**The new rodless cylinder model MCRPLK2 is now replacing the MCRPLK model, featuring integrated sensor functionality.**

1. Model series

MCRPLK-Ø16~Ø40.

Product Change Notification  
設變通報

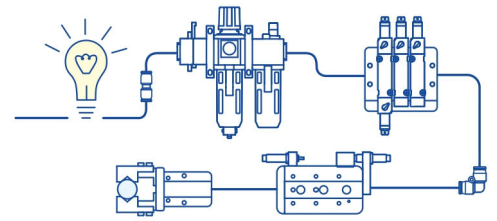
- ◆ Various sensors have been integrated into the RDT model for simplification.
- ◆ Due to a profile change, the old MCRPLK model has been replaced by the new MCRPLK2 model.
- ◆ In order to be compatible with the new sensor, the profile size of Ø32/Ø40 needs to be changed, as the table displays.

Before	After																		
<p>1. Model :</p> <p style="text-align: center;">MCRPLK</p>	<p>1. Model :</p> <p style="text-align: center;">MCRPLK<sup>2</sup></p>																		
<p>2.</p> <div style="display: flex; justify-content: space-around;">  </div> <table border="1" style="width: 100%; text-align: center;"> <thead> <tr> <th>Tube I.D.</th> <th>Z1</th> <th>Z2</th> </tr> </thead> <tbody> <tr> <td>32</td> <td>52</td> <td>48</td> </tr> <tr> <td>40</td> <td>58</td> <td>58</td> </tr> </tbody> </table>	Tube I.D.	Z1	Z2	32	52	48	40	58	58	<p>2.</p> <div style="display: flex; justify-content: space-around;">  </div> <table border="1" style="width: 100%; text-align: center;"> <thead> <tr> <th>Tube I.D.</th> <th>Z1</th> <th>Z2</th> </tr> </thead> <tbody> <tr> <td>32</td> <td>52</td> <td><b>51</b></td> </tr> <tr> <td>40</td> <td><b>58.5</b></td> <td><b>59</b></td> </tr> </tbody> </table>	Tube I.D.	Z1	Z2	32	52	<b>51</b>	40	<b>58.5</b>	<b>59</b>

Tube I.D.	Z1	Z2																	
32	52	48																	
40	58	58																	
Tube I.D.	Z1	Z2																	
32	52	<b>51</b>																	
40	<b>58.5</b>	<b>59</b>

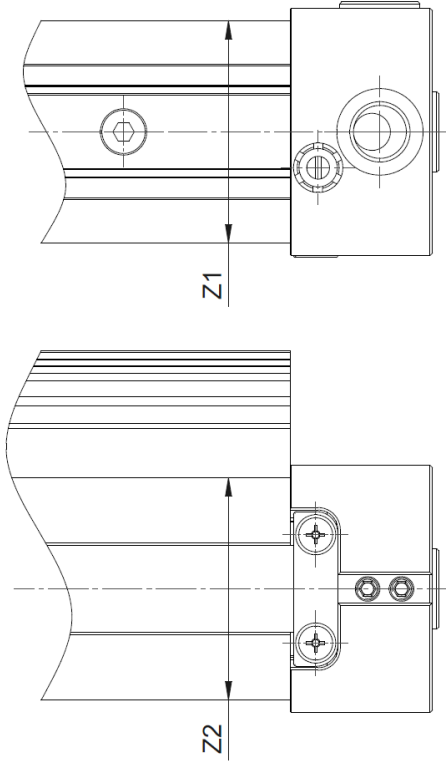
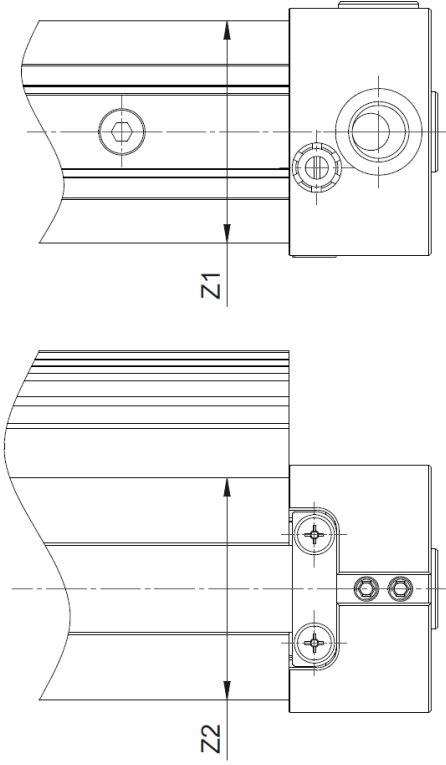
Please see the tables in page 2 and 3.

Before	After	
<p>MCRPLK-Ø16~Ø40 sensor</p>  <p>Sensor : RCAL</p> <p>Switch holder : HPL</p>	<p>MCRPLK2-Ø16 / Ø25 sensor</p>  <p>Sensor : RDT</p> <p>Switch holder : HPL2</p>	<p>MCRPLK2-Ø32 / Ø40 sensor</p>  <p>Sensor : RDT</p>
